TECHNICAL EVALUATION REPORT

OPERATING REACTOR PORV REPORTS (F-37) TMI ACTION PLAN REQUIREMENTS

GENERIC REPORT -- BABCOCK & WILCOX DESIGNED UNITS

July 20, 1983

Figure 1. B&W Calculation

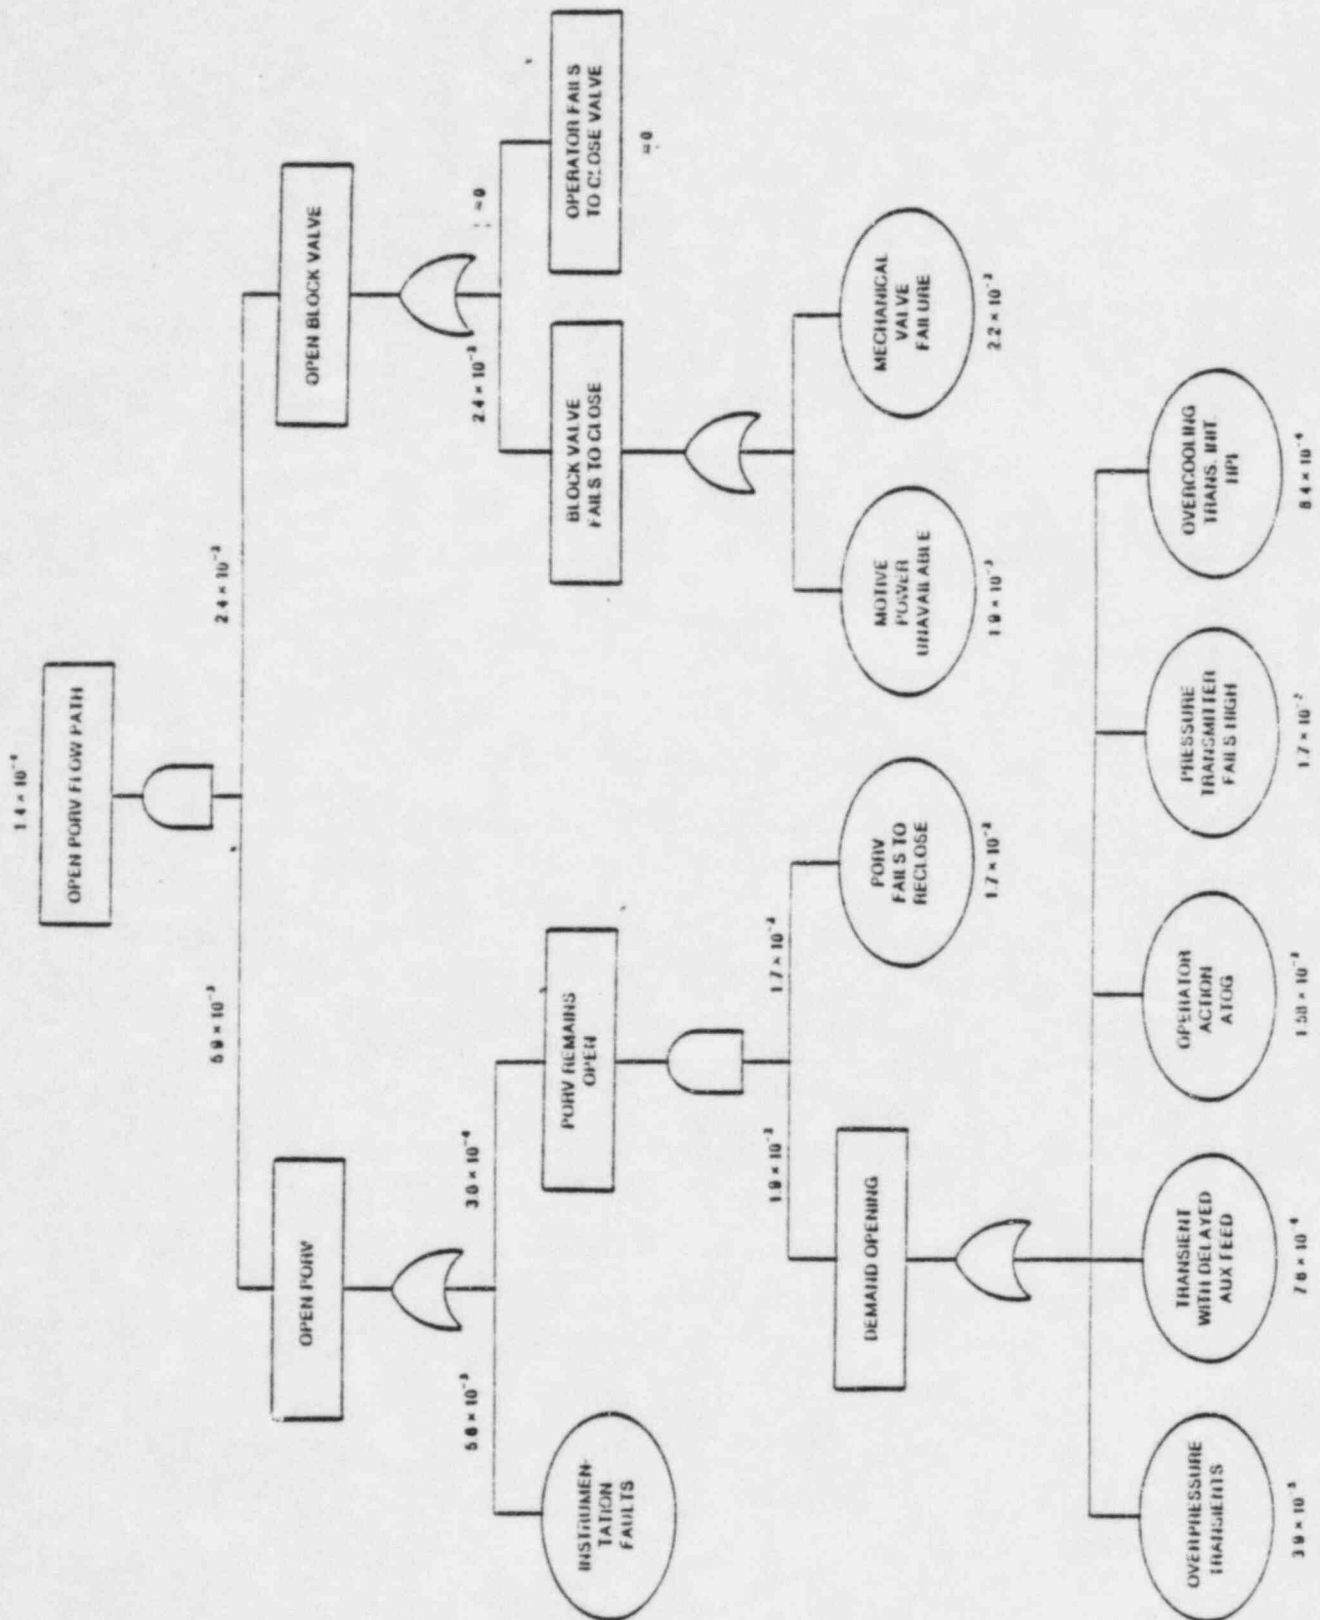
As shown in Figure 1, B&W determined the recurrence frequency of a small-break LOCA from a stuck-open PORV by multiplying the probability of the PORV remaining open with the probability of the block valve remaining open. The probability of the PORV remaining open is the sum of openings due to instrumentation faults and openings due to other demands multiplied by the probability of the PORV to fail to close. Figure 1 shows that B&W determined the probability of a small-break LOCA from a stuck-open PORV to be 1.4×10^{-4} per reactor-year.

Figure 2 shows the same calculation revised in accordance with the comments and discussion developed in this section of the report. It includes changes made to the initiator frequency for overpressure transients (2.2×10^{-3} rather than 3.9×10^{-5}), the initiator frequency for operator action under ATOG guidelines (7.7×10^{-2} rather than 1.58×10^{-2}) and the probability of the operator failing to shut the block valve when required (1.5×10^{-2} per demand rather than 0). As result of this recalculation, the probability of a small-break LOCA from a stuck-open PORV is 2.53×10^{-4} per reactor-year. While this value is somewhat larger than the value determined by B&W, it is quite comparable and is also well below the median WASH-1400 frequency for a small-break LOCA of 1×10^{-3} .

Figure 3. (Page 1) Revised Calculation, Considering Multiple PORV Cycles

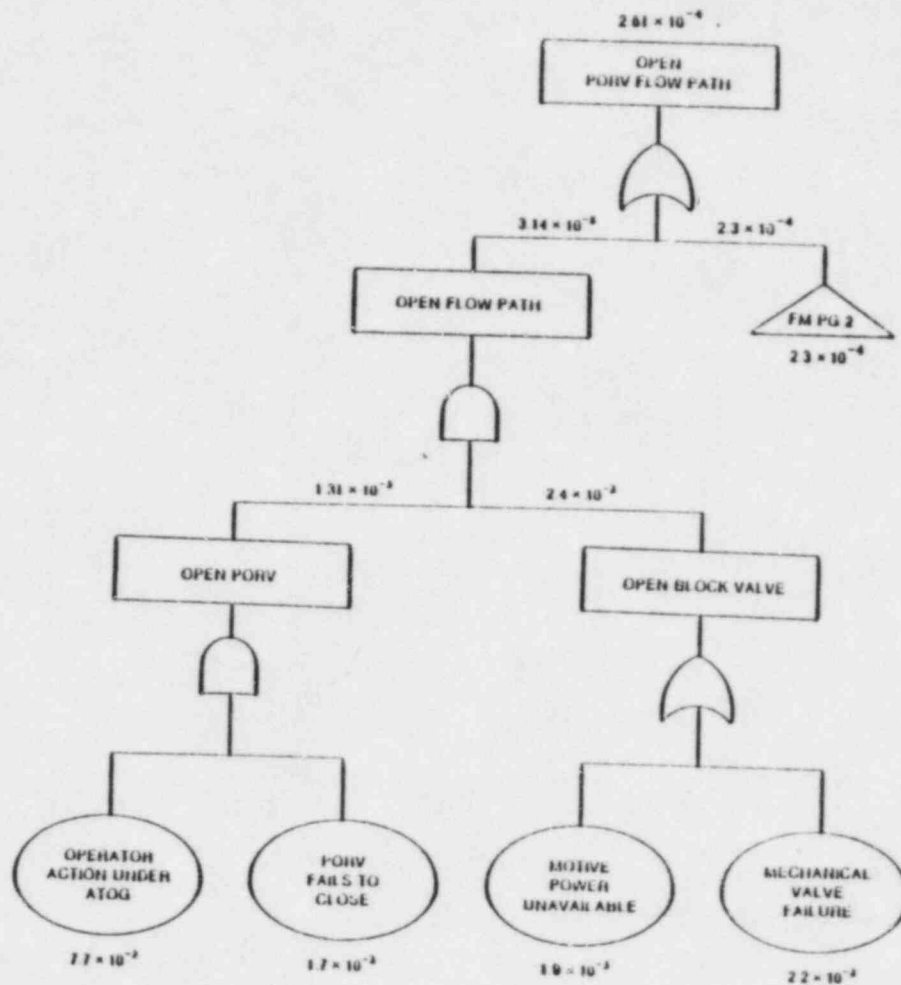
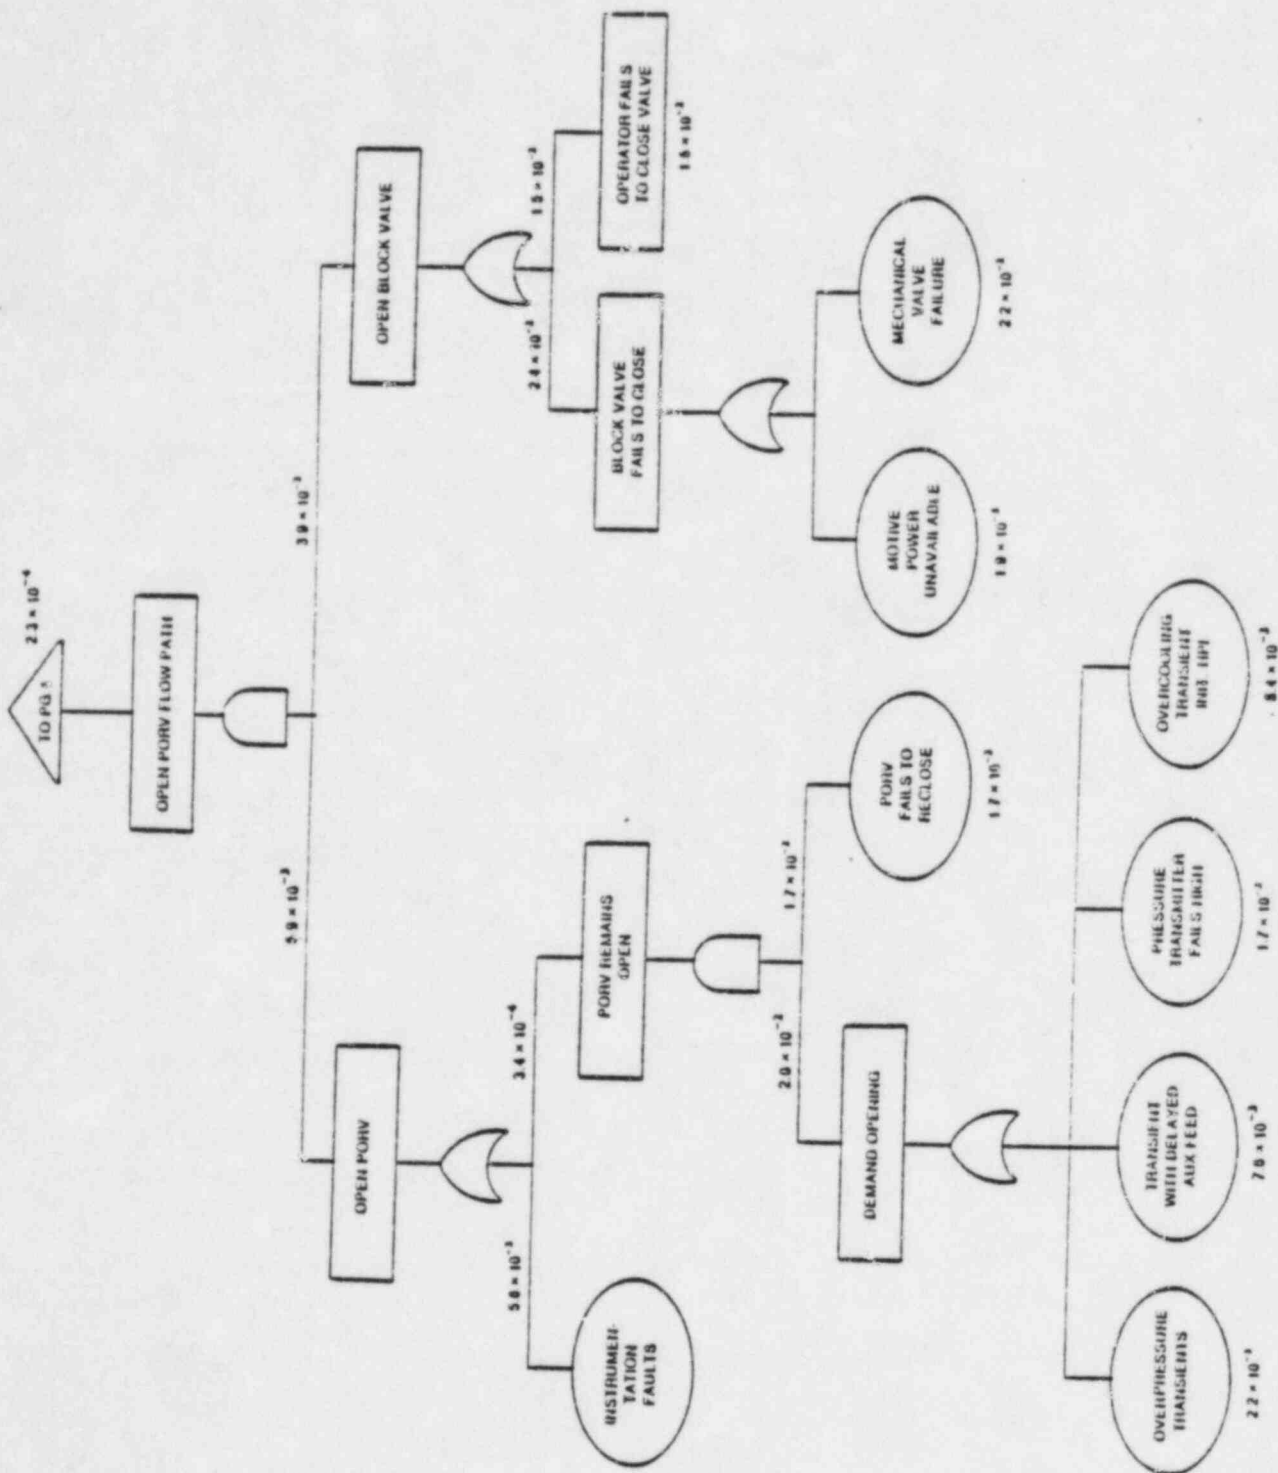
The revised calculation of Figure 2 (discussed in Section 3.2.1.2) has been updated to include the effect of multiple PORV cycles. The results of this updated analysis are given in Figure 3. Figure 3 shows a small-break LOCA probability of 2.61×10^{-4} per reactor-year, a 3.3% increase over the value calculated in Figure 2. These calculations show that multiple PORV cycles is not a primary concern for B&W-designed units.

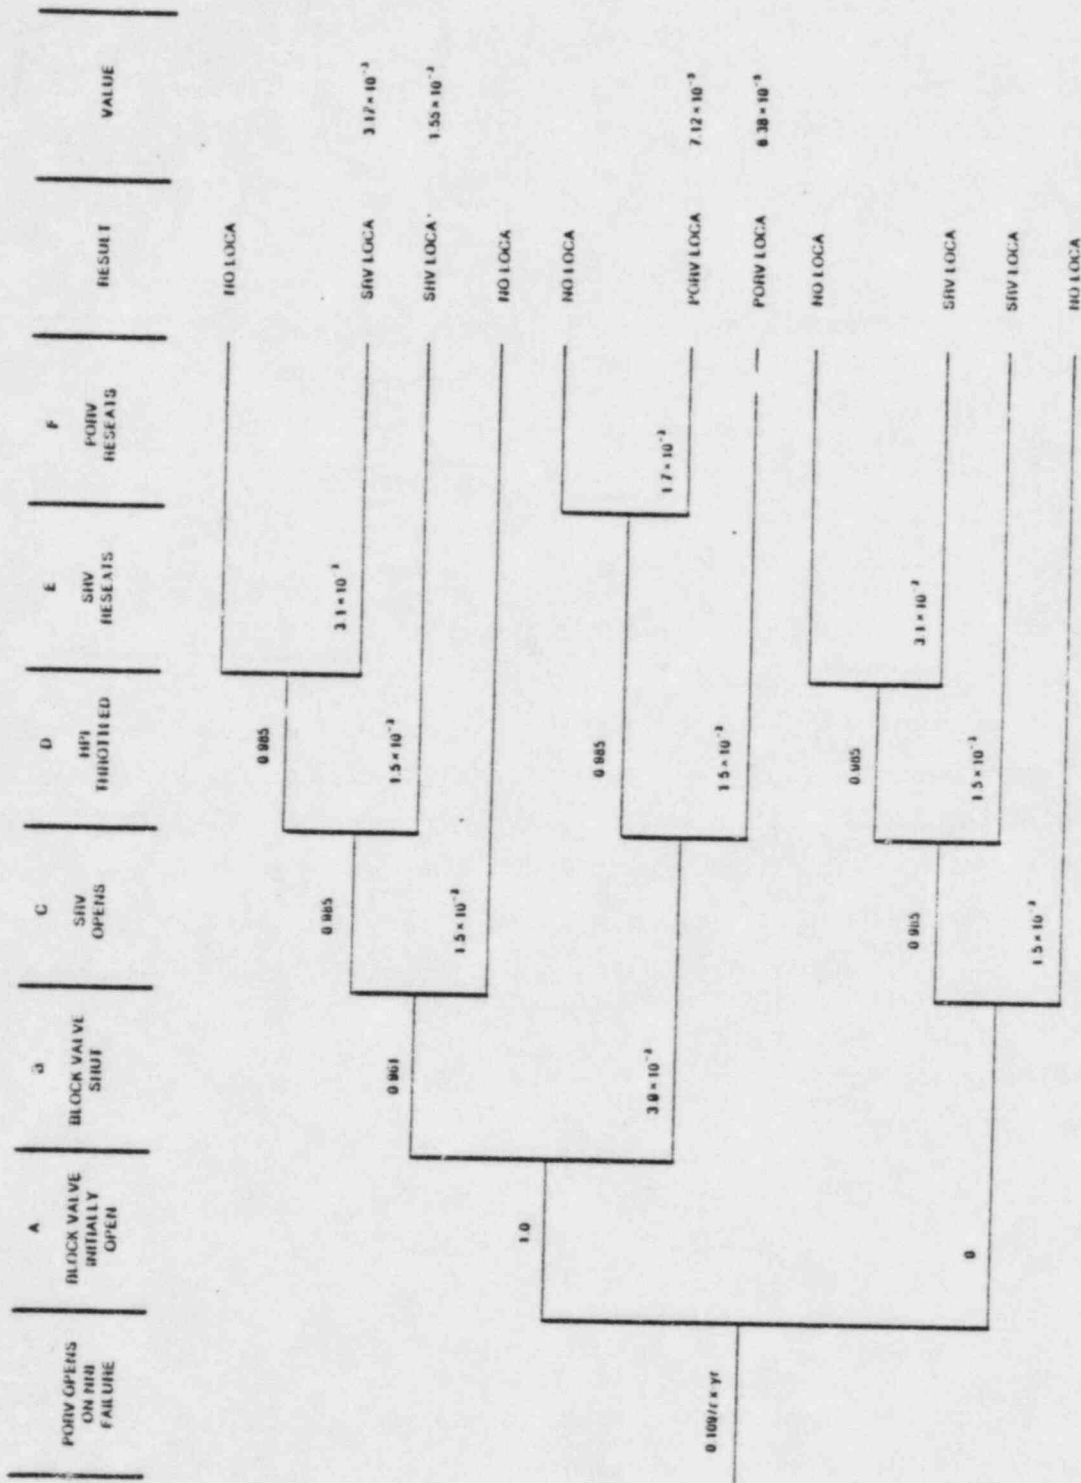
As shown in Figure 4, the small-break LOCA probabilities resulting from this analysis are:

The results indicate that the probability of a small-break LOCA from a stuck-open PORV or SRV remains within the WASH-1400 range of 10^{-2} to 10^{-4}

Figure 5. Overpressure Events - Theoretical Calculation Based on Normal Distribution of Setpoints (Block Valves Open)

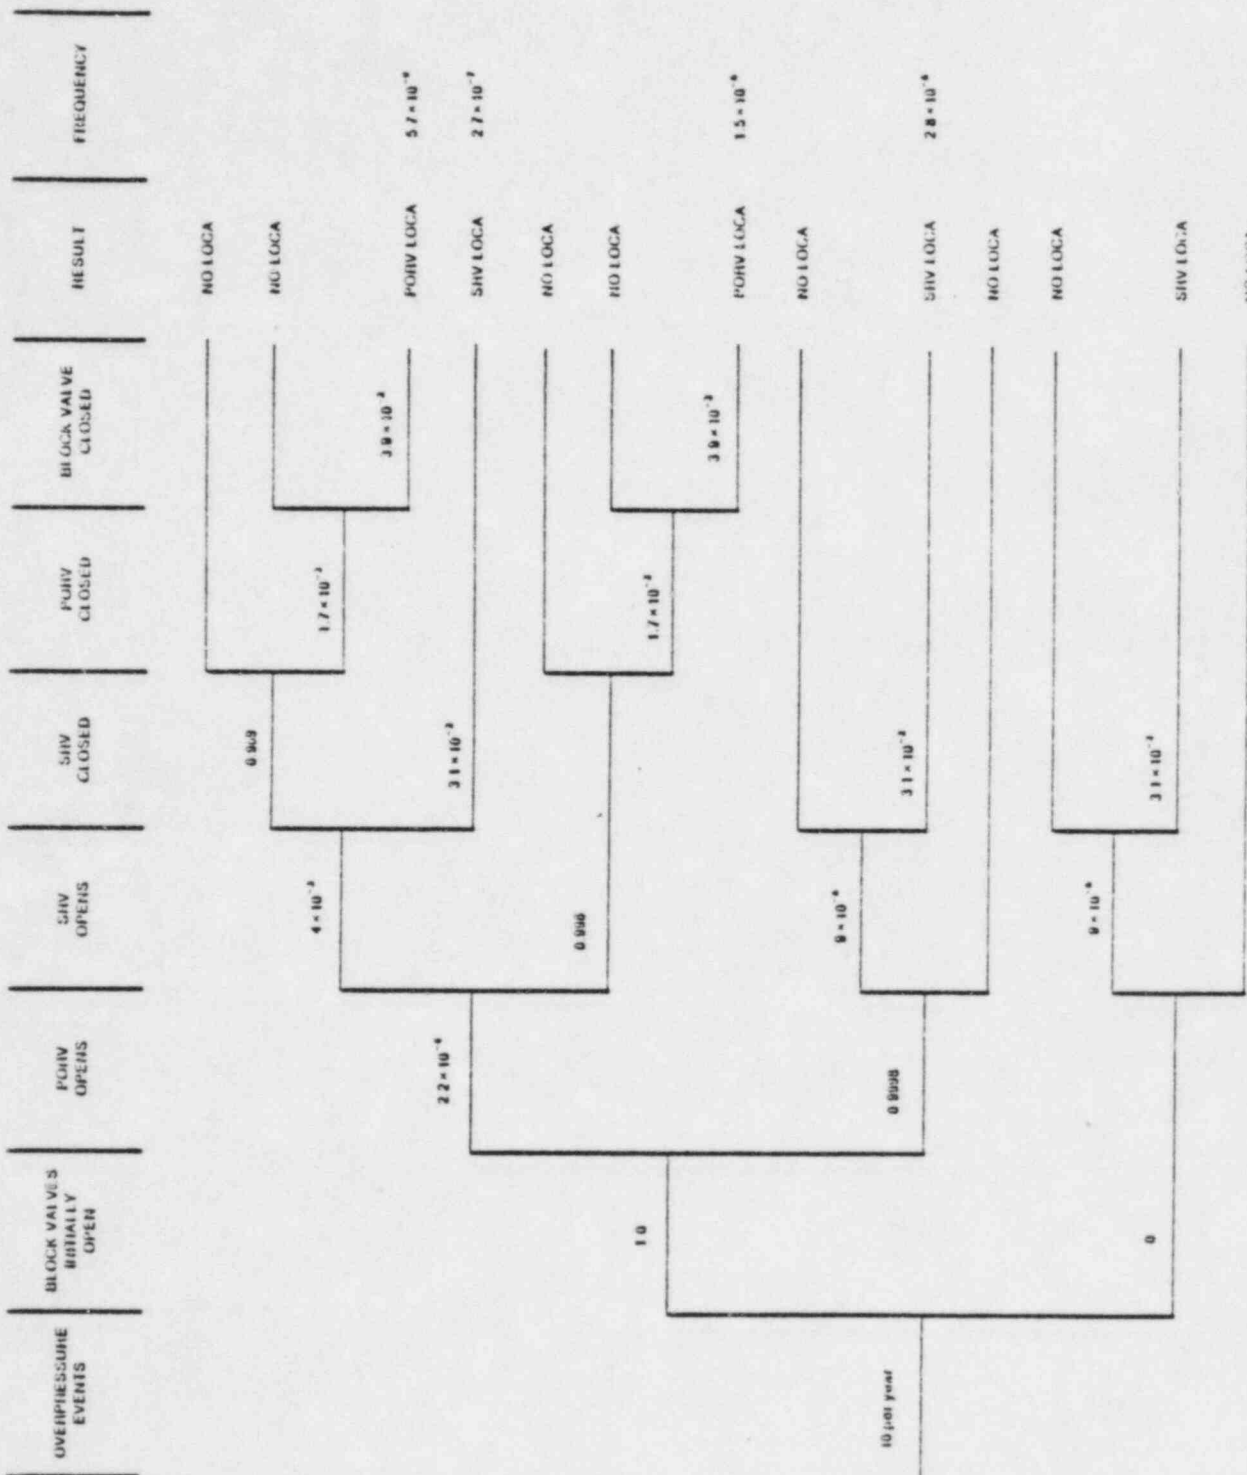
<u>Block Valves 100% Open (Figure 5)</u>	<u>Block Valves 100% Closed (Figure 6)</u>
Stuck-open PORV per rx-yr	1.5×10^{-6}	Not applicable
Stuck-open SRV per rx-yr	3.1×10^{-6}	2.8×10^{-6}

1. The assumption of normality is at its worst in the tails of the distributions, the areas of primary focus of this analysis.
2. The dependence of the PORV and the SRV is not accounted for, i.e., if the PORV opens, the RCS peak pressure will probably be less than if it does not open.
3. The variances (standard deviations) of the PORV and SRV setpoint distributions are based upon a limited amount of test data and are not based upon actual in-plant operating conditions [11].

Figure 7. BAW Calculation -- vi-Bess

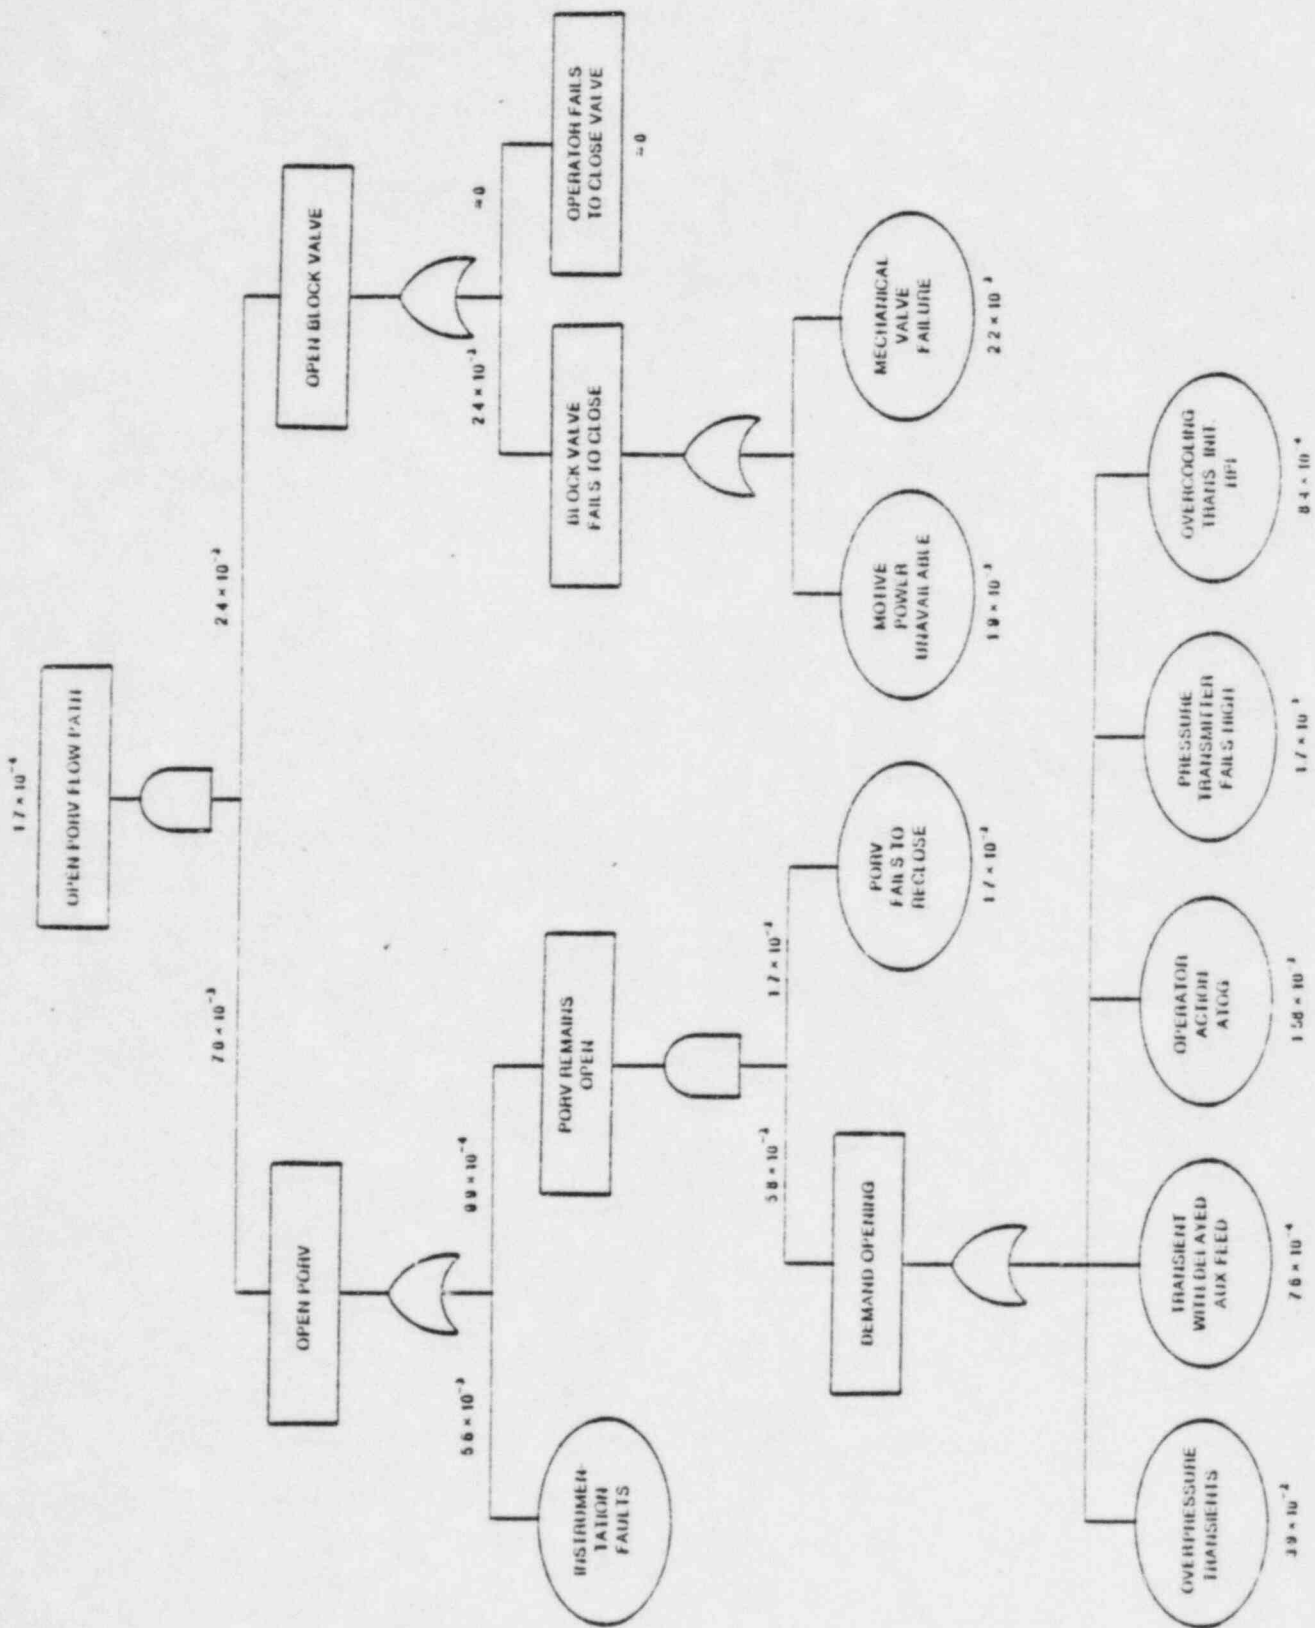
Using the Davis-Besse PORV opening rate of 5.8×10^{-2} per reactor-year, the calculation of Figure 1 of this report was repeated. The resulting probability of a small-break LOCA from a stuck-open PORV was as follows:

All B&W units except Davis-Besse Figure 1	Davis-Besse Figure 7
$1.4 \times 10^{-4}/\text{rx-yr}$	$1.7 \times 10^{-4}/\text{rx-yr}$
